**SERVICE BULLETIN**

**APPLICABILITY:** 2019-21MY Forester

**NUMBER:** 12-239-21

**SUBJECT:** Non-Power Rear Gate Stay / Design Change

## Identification:

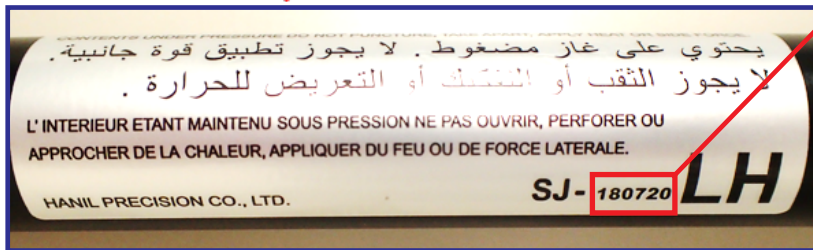
It is important to identify the production date code of the rear gate stay assemblies to verify if new parts have or have not been installed on to the vehicle. If the new parts are already installed, confirm fault sources such as mechanical resistance, gate alignment, physical damage etc. are not the cause before proceeding with rear gate stay replacements.

Replace BOTH rear gate stay assemblies if a production date code number lower than **210517** is found.
